B Verification Memo — WO-03 Compute Node Selection, Round 3

Verification view of WO-03: recomputed gate panel (all four pass) and energy ladder P3 10 Wh < P2 22 < P1 28 < P4 49, with gaps +12/+18/+39 Wh above the minimum.

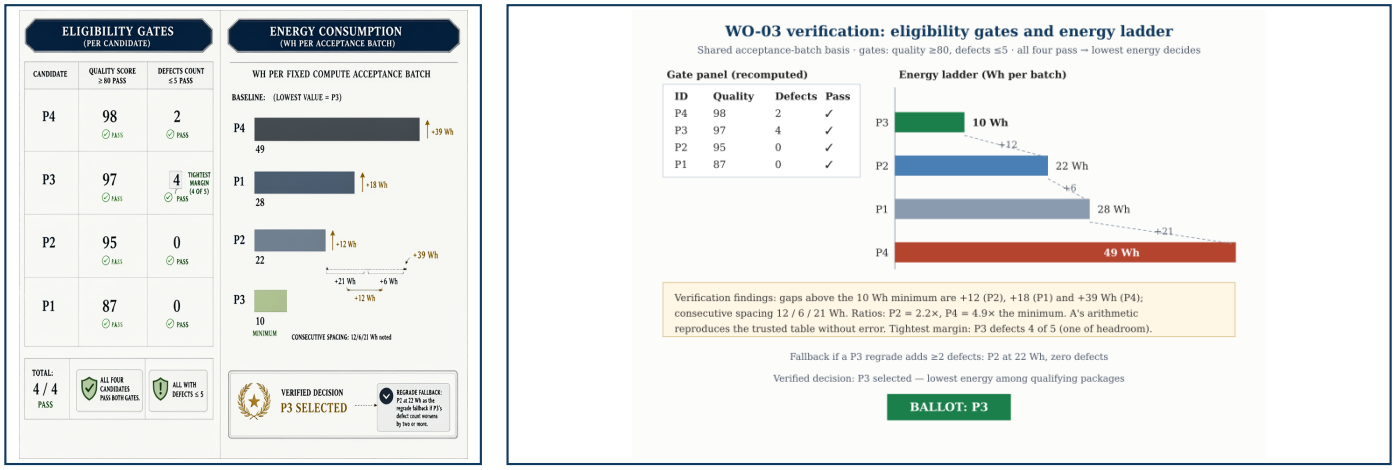
The policy admits a package only at quality ≥80 and raw defects ≤5. From the trusted table: quality P4 98, P3 97, P2 95, P1 87 — all clear, with P1's margin smallest at +7. Defects: P1 0, P2 0, P4 2, P3 4 — all within 5, with P3 tightest at one defect of headroom. No package is excluded, so the lowest-ID tie-break never activates; selection reduces to minimizing measured energy. This reproduces A's gate panel exactly; I find no arithmetic error in A's eligibility table.

Verified order on the shared acceptance-batch basis: P3 10 Wh < P2 22 < P1 28 < P4 49. Gaps above the minimum are +12, +18 and +39 Wh; consecutive spacing is 12, 6 and 21 Wh — a tight P2–P1 cluster and a wide P1–P4 tail. A's ratios also check: P2 costs 2.2× and P4 4.9× the 10 Wh minimum. No tie exists, so no tie-break applies. A's ladder statements match the trusted table, and the P3 recommendation follows directly from the energy-first policy with no discretionary quality weighting.

Each decision-relevant claim was checked against the table. P3's defect margin: correct — it holds 4 of 5 permitted raw defects, so a regrade adding two or more disqualifies it and moves the win to P2 at 22 Wh with zero defects. P4: correct — even a clean regrade to zero defects cannot offset the 39 Wh penalty under the energy rule. P1: correct — 87 quality leaves a 7-point margin; P2's zero-defect record is the most regrade-robust. A properly flags cost, delivery, maintenance and field reliability as unverified rather than asserting them.

P3 is independently confirmed as the client winner: all gates pass, its 10 Wh measured energy is the lowest, and it leads runner-up P2 by 12 Wh on the identical basis. My recomputation matches A's arithmetic throughout; the 4/5 defect ceiling is a monitored contingency with P2 (22 Wh, zero defects) as fallback. Ballot: P3.
